CHANGE ORDER

DATE OF ISSUANCE 2/8/2019 EFFECTIVE DATE No. 4  
2/8/2019

PROJECT: 2018 Water System Improvements

OWNER City of Oregon City

# C11

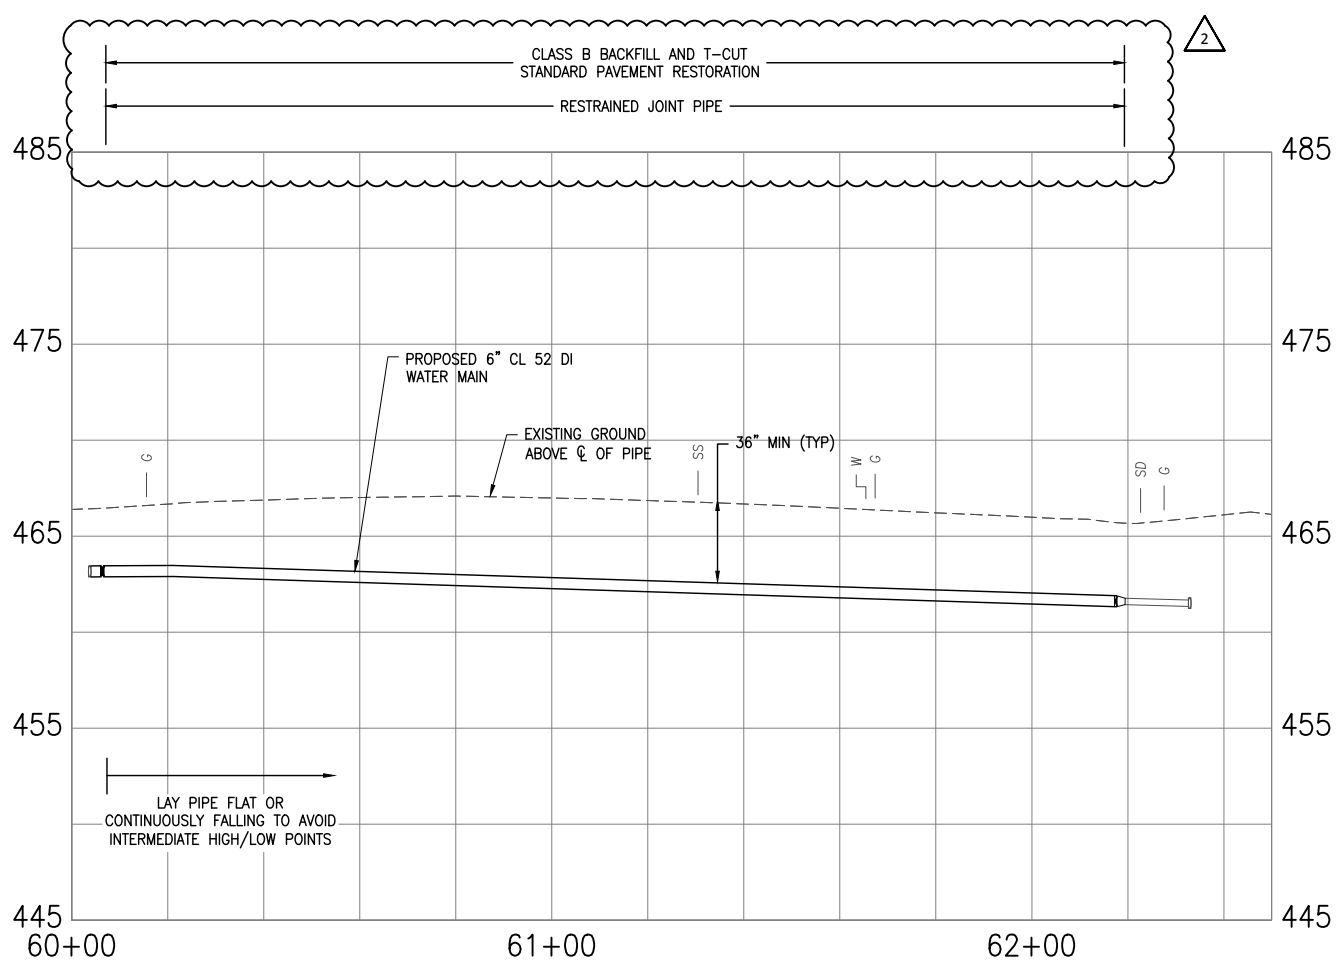
#### **Item 4.4: Changes to Warner Avenue connection at Molalla Avenue**

Description: Modify the proposed improvements per the sheet revisions to sheet C11.

Reason for Change Order: After potholing the existing valve near Molalla Avenue and Warner Street and verifying the configuration of the existing waterline fittings, it was determined that replacing the piping and valve all the way to the existing waterline in Molalla Avenue was not appropriate at this time. The improvements removed with this change order are anticipated to be completed with future waterline improvements on Molalla Avenue. Multiple bid item unit quantities are modified as a result of this change as follows:

Bid Item 2: Reduce lump sum value by \$250.00.

Bid Item 12: Reduce by 162 SY at the unit contract price of \$95.00/SY.

Bid Item 18: Increase unit quantities by 20 LF at the unit contract price of \$74.00/LF.

Bid Item 19: Reduce unit quantities by 35 LF at the unit contract price of \$195.00/LF.

Change in Contract Price: Work under Change Order Item 4.4 will modify the estimated contract quantities and result in a decrease in contract price totaling (\$20,985.00)

4 CHERRY STREET & PARK DRIVE

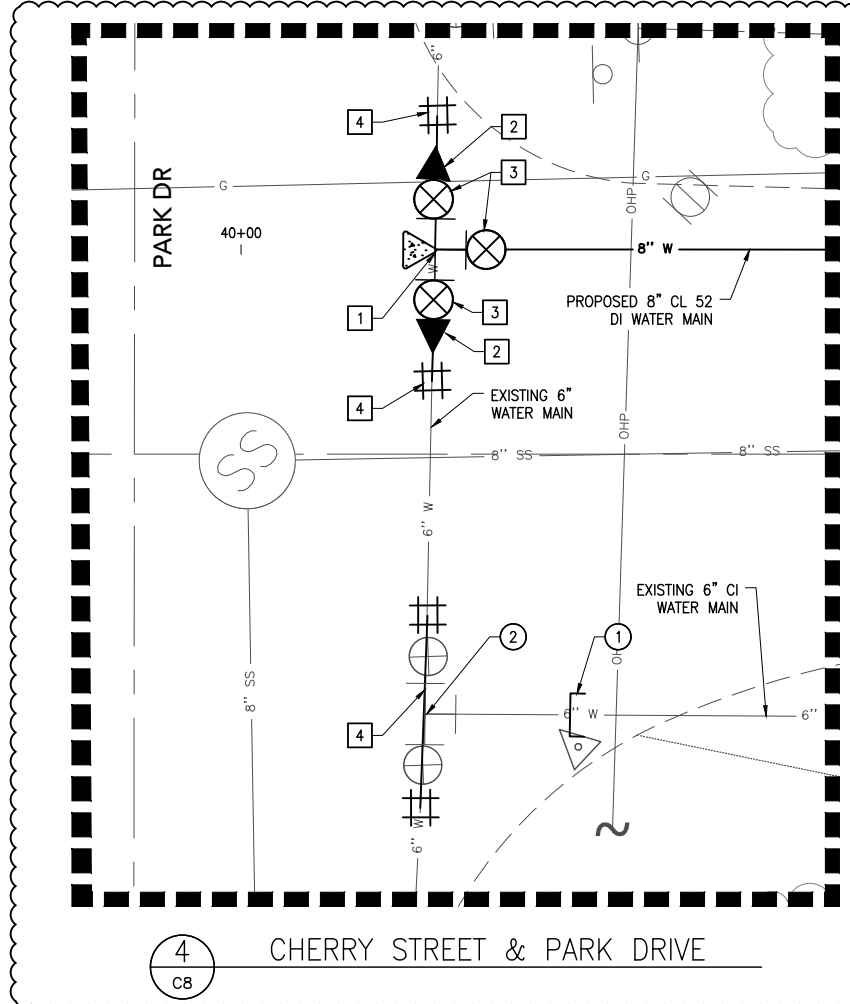
**Item 4.3: Remove existing tee and 2 existing valves on Park Avenue**

Description: Remove the existing tee and the two existing valves on Park Avenue that connect to the existing water main on Cherry Street which is replaced with this project as shown on revised C13.

Reason for Change Order: It was identified that removing the existing tee and connected valves would be advantageous for the future operation of the water system once this project is complete. It also removes additional valves on the system that provide little redundancy benefit but still require annual maintenance.

Also, we spoke about sheet C13, detail 4 – remove the existing tee and valves and replace with sleeves and a short spool of pipe. This would remove the valves permanently, and given the new cluster we're installing there'll be adequate isolation points, with two potential failure points removed.

- REMOVE: EXISTING PIPING AND FITTINGS AS NECESSARY TO PERMIT INSTALLATION OF PIPE AND FITTINGS SHOWN.
- ① ABANDON PIPE AND FILL W/ CLSM
  - ② REMOVE EXISTING TEE AND VALVES
- INSTALL:
- ① 1 ~ 8" FL TEE W/ THRUST BLOCK
  - ② 2 ~ 6" X 8" MJ REDUCER AND 8" DI SPOOL
  - ③ 3 ~ 8" FL X MJ GV
  - ④ 3 ~ 6" PE DI SPOOL AND COUPLING

We could do that work, all inclusive (labor, equip, materials) for \$1,050. Please let us know if the city would like us to do that while we're there.

DRAWING NO:  
**C4**  
4 OF 17

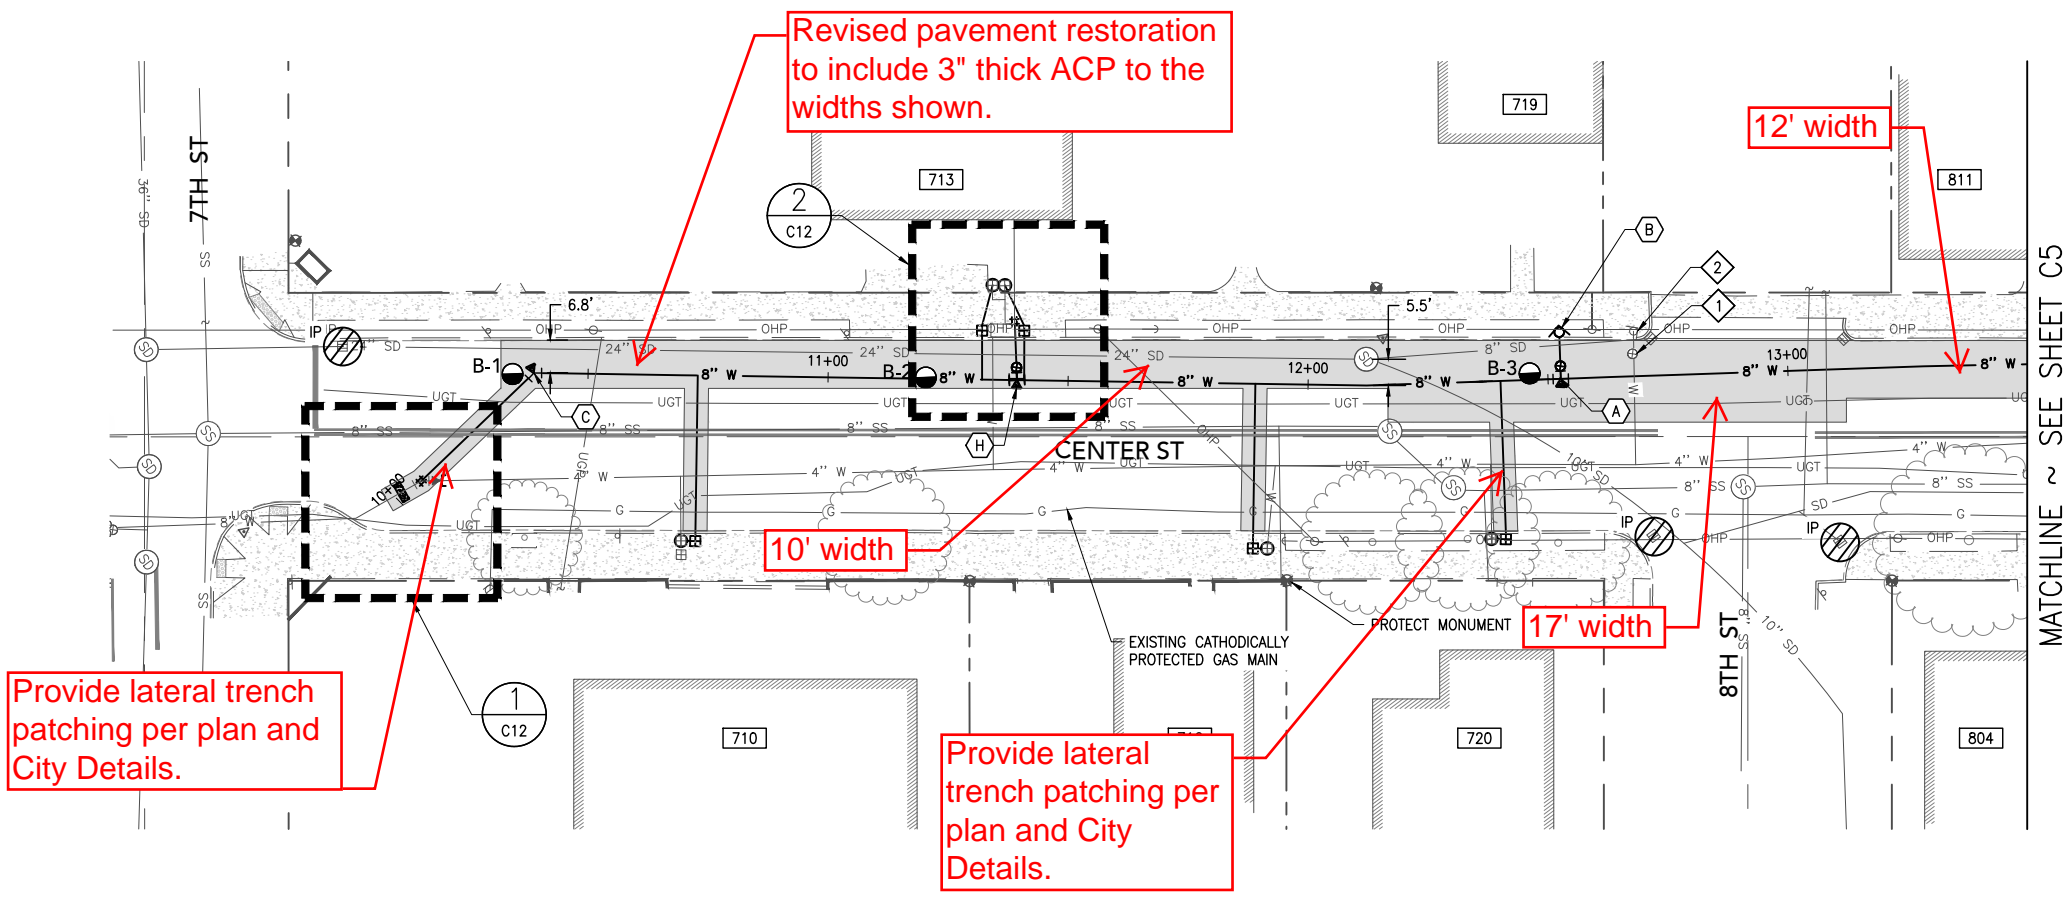
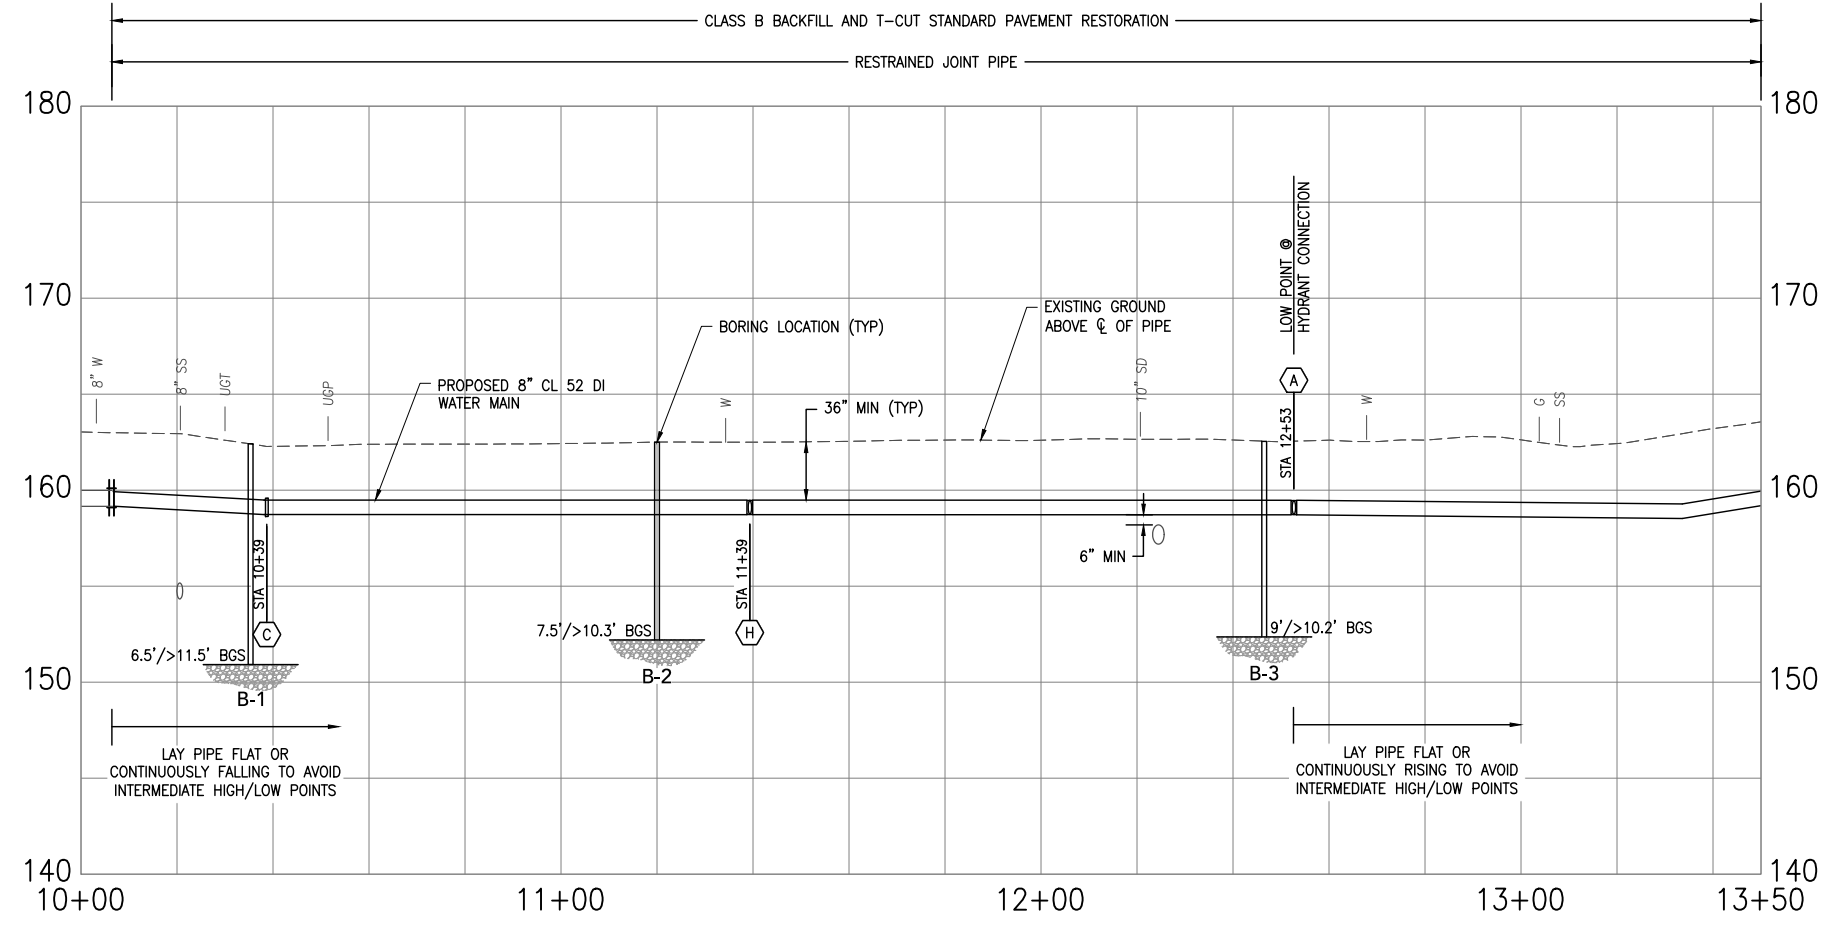
#### **Item 4.5: Changes to pavement restoration on Center Street and 9<sup>th</sup> Street**

Description: Construct pavement restoration on Center Street and 9<sup>th</sup> Street per the attached Exhibit 1

Reason for Change Order: Pavement disturbance created as a result of the waterline installation will require additional asphalt restoration beyond the typical trench patching shown in the plans. The existing quality of the asphalt, presence of shallow rock and existing thickness of the asphalt all resulted in trenches of varying width. To adequately restore the asphalt on Center and 9<sup>th</sup> Street, wider pavement restoration is required to restore the road to an acceptable condition.

#### **Item 4.6: Typical trench restoration changes**

Description: Construct the typical trench restoration per the Contract plans except change the final asphalt thickness to 3 inches instead of 5 inches. Trench restoration on Holmes Lane will have a 4 inch thickness.

Reason for Change Order: Following excavation of the waterline, it was observed that the existing pavement thicknesses were less than that proposed for the permanent trench restoration. Revising the permanent trench restoration to a 3 inch thickness will more closely match the asphalt section of the existing roadways. Holmes Lane will be modified to a 4 inch thick trench patch.

Bid Item 4.5 A – Center and 9<sup>th</sup> Permanent ACP restoration. 1,800 SY @ \$35.60/SY = \$64,080.00

Bid Item 4.6 A – Trench Resurfacing, Permanent ACP, 3-Inch Depth. 1,233 SY @ \$35.60/SY = \$43,894.80

Bid Item 4.6 B – Trench Resurfacing, Permanent ACP, 4-Inch Depth. 20 SY @ \$47.90/SY = \$958.00

C7

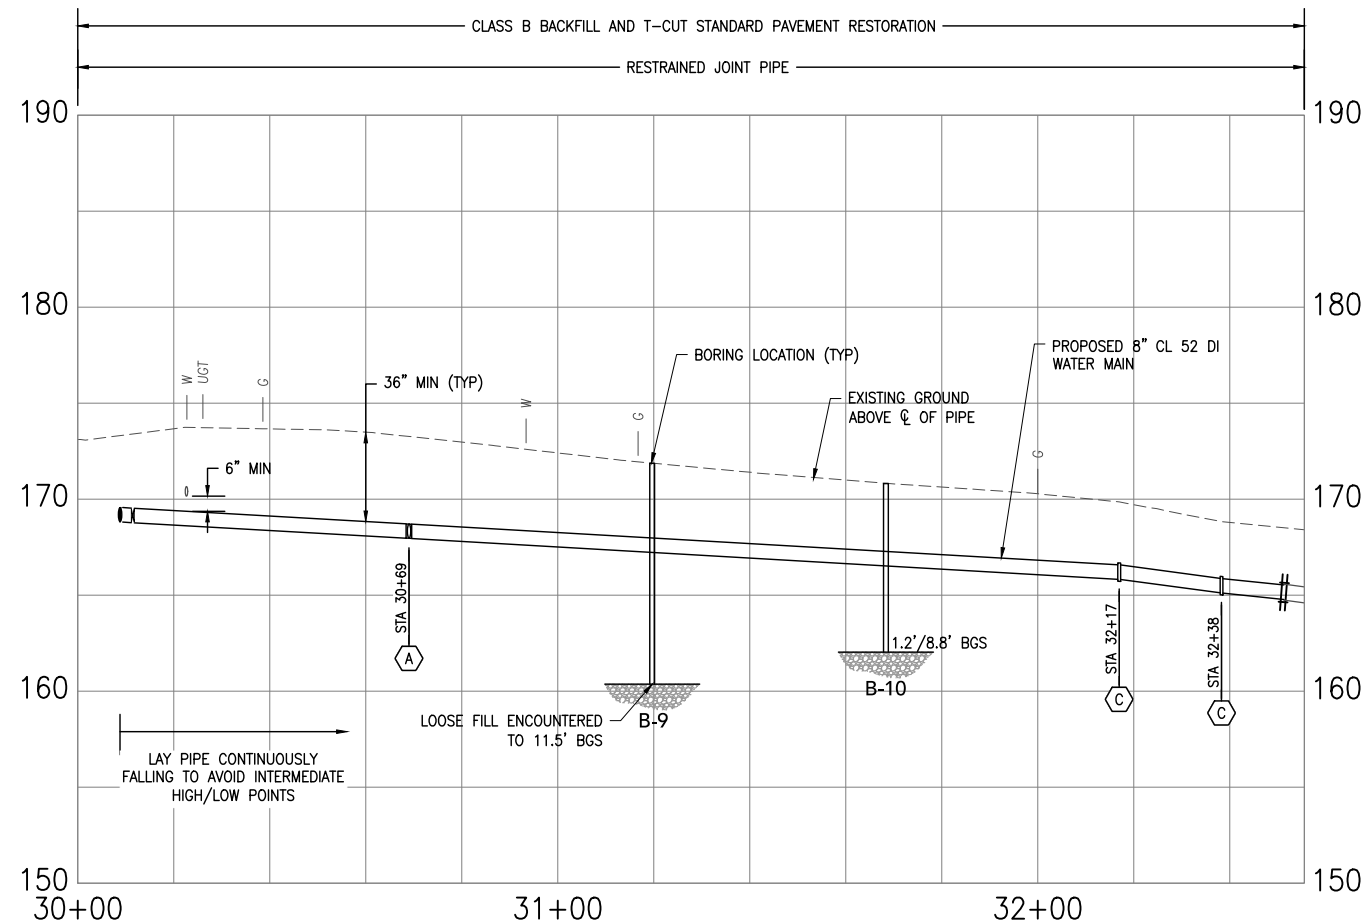
**Item 4.8: Modify fire line connection to 824 Center Street authorized with Change Order 2**

Description: Modify the work proposed in Change Order 2 to include installing a new 4 inch diameter fireline, including the tee and valve at the main, installing a new 4 inch valve prior to the existing curb, capping the new line after the new valve, providing a 2 inch diameter port and riser in the planter strip and cutting and capping the existing fire line behind the curb.

Reason for Change Order: Following execution of Change Order 2, the City identified that the discovered fire line should not be reconnected to the existing fire line due to concerns with inadequate backflow prevention inside the existing structure. Alternatively, the City directed the Contractor to modify the work described in Change Order 2 to include providing a new fire line but not connecting it to the existing fire line at this time. This will allow future connection to the fire line when all backflow prevention devices are brought up to code, but will not require disturbing the street or recently constructed water improvements.

- (1) ABANDON: (TYP 2)  
1 ~ EXISTING VALVE
- (2) ABANDON: (TYP 1)  
1 ~ EXISTING FIRE HYDRANT
- (H) INSTALL: (TYP 1)  
1 ~ 8" X 4" FL X MJ TEE W/ THRUST BLOCK  
1 ~ 4" FL X MJ GV  
CUT TEE INTO RECENTLY INSTALLED WATER MAIN W/ SLEEVE AND SPOOL ON ONE SIDE AS NEEDED.
